To: Fatih Gordu, P.E., Chief Water Resources Engineer, SJRWMD

From: Silong Lu, Ph.D., P.E., D.WRE, Dynamic Solutions, LLC.

Date: 1/21/2020

Re: **INDEPENDENT TECHNICAL PEER REVIEW SERVICES**
REVIEW OF LAKE SYLVAN HSPF MODEL-DEVELOPMENT, DOCUMENTATION, AND LONG-TERM
SIMULATION REVIEW

Figure 1 Land Locked Lakes Basin

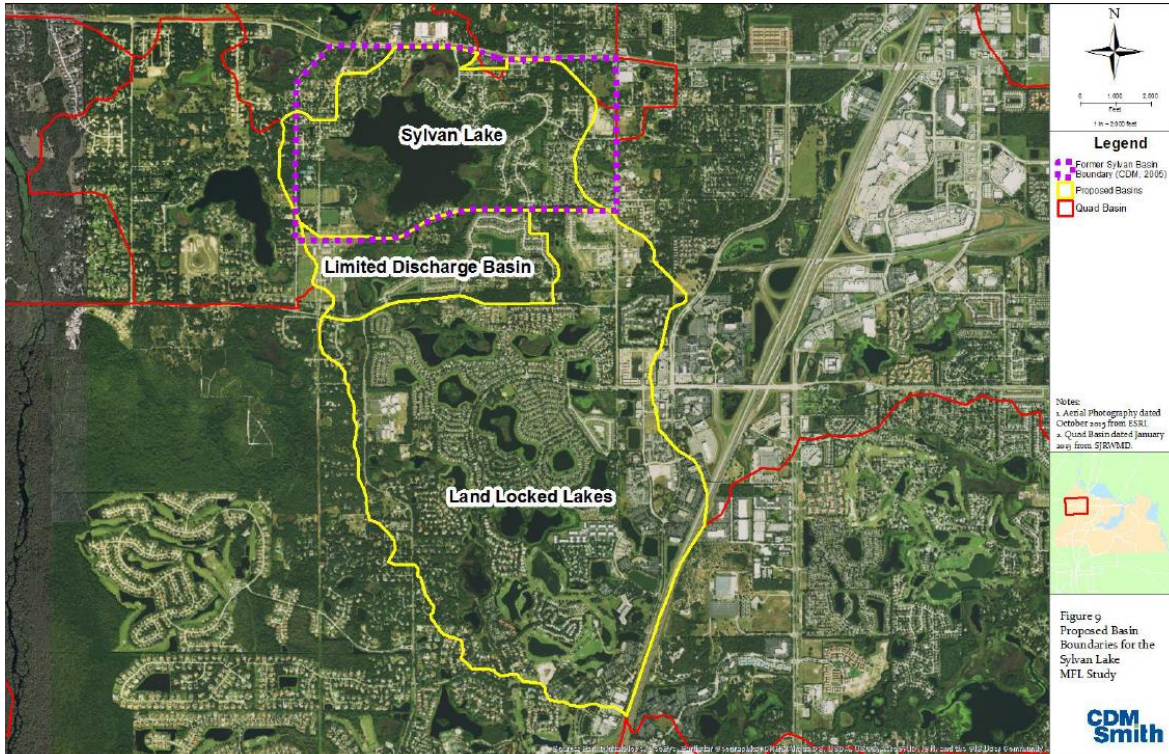
Based on review of the groundwater table elevation map (CDM Smith, 2017), the Land Locked Lakes basin (Figure 10 of Appendix A, CDM Smith, 2017) as shown Figure 1 below, in which groundwater is unlikely to flow toward Lake Sylvan was excluded and not simulated for this study.

Figure 2 Limited Discharge Basin

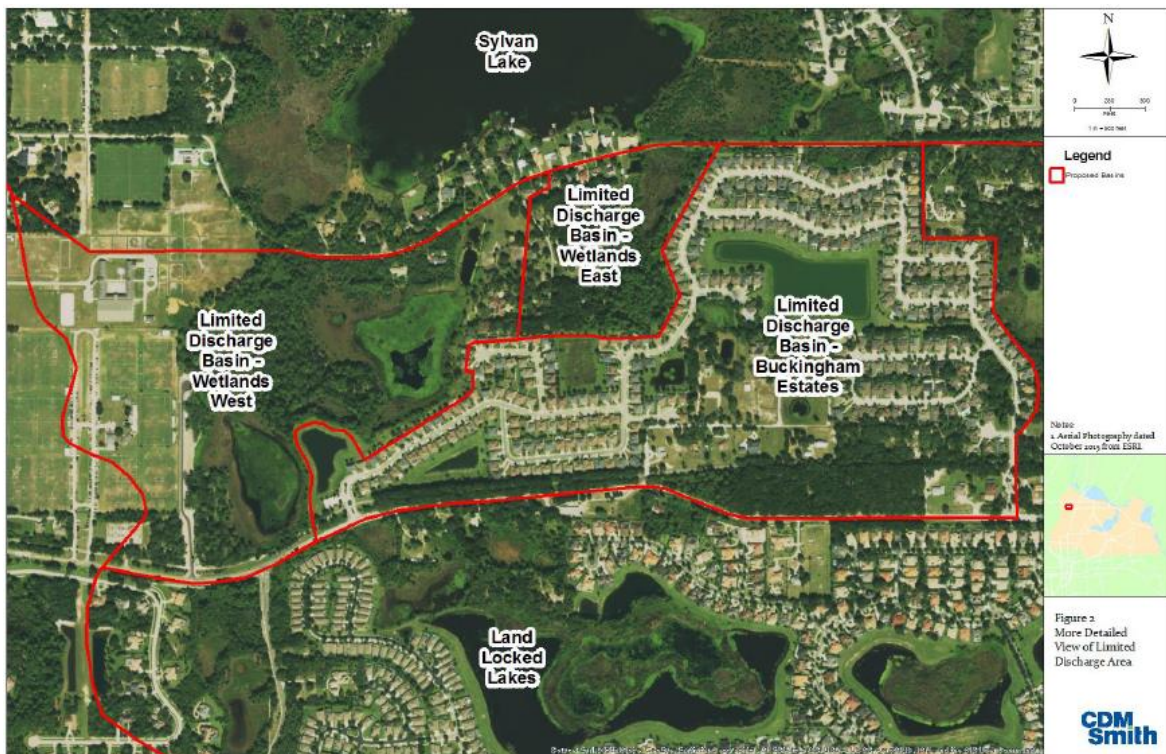
The Limited Discharge Basin was further delineated into three different sub-basins based on the field observation (Figure 2 of Appendix B, CDM Smith, 2017) as shown in Figure 2 below. Limited Discharge Basin-Buckingham Estate was expected to contribute groundwater flow only to the lake and Limited Discharge Basin-Wetlands West discharged surface flow only from the storage area south of South Lake Sylvan Road to the lake when South Lake Sylvan Road is overtopped at an elevation of 44 ft NAVD. The modeled seepage flow from the storage area was considered to discharge to Lake Sylvan as groundwater flow. Limited Discharge Basin-Wetlands East, which is connected by a 12-inch culvert with the estimated invert of 38 ft NAVD under South Lake Sylvan Road, was considered part of the Direct Tributary Area to Lake Sylvan.
